## CERTIFICATE OF APPROPRIATENESS

**ISSUED: November 8, 2022**

This letter provides you with confirmation that the proposed changes to your designated Fort Collins landmark property, the Carnegie Library at 200 Mathews St., have been approved by the City's Historic Preservation Division because the proposed work meets the criteria and standards in Chapter 14, [Article IV](#) of the Fort Collins Municipal Code.

# A5 - SITE PLAN

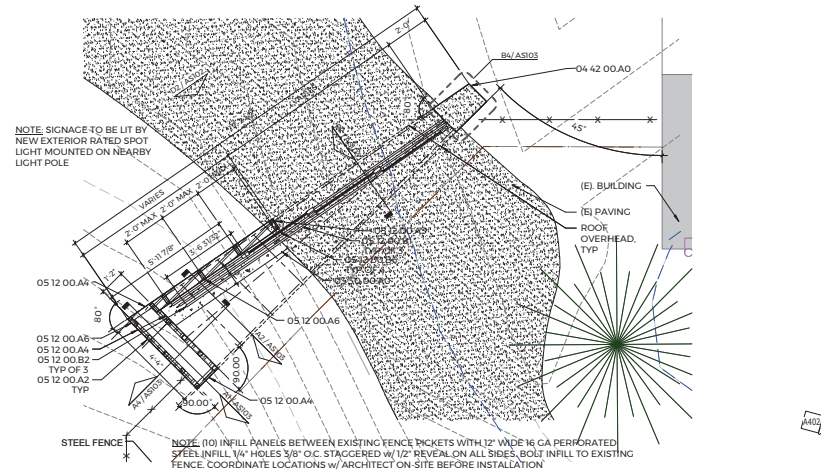
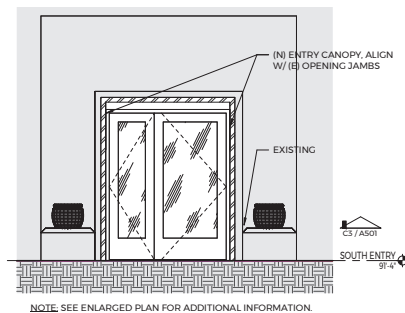
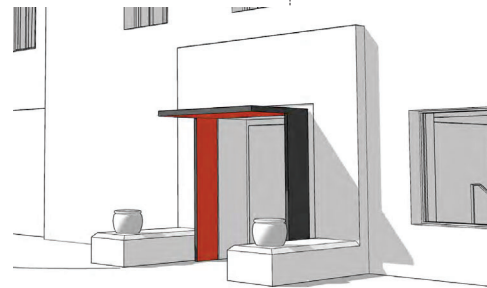
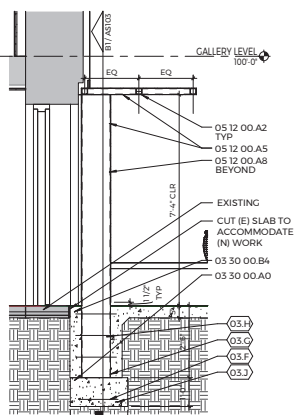
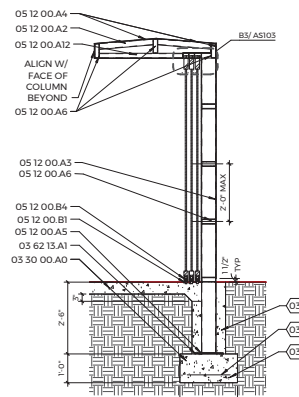
- 1) Demo of existing monument sign for Carnegie Center for Creativity by west elevation.
- 2) Heritage Courtyard gate replaced with structure with sliding gate panels and "Carnegie Center for Creativity" vinyl sign.

- 5) New freestanding canopy for south elevation door.
- 6) Replacement of south door with two-leaf wood door (Door 101A); existing hollow metal frame reused.
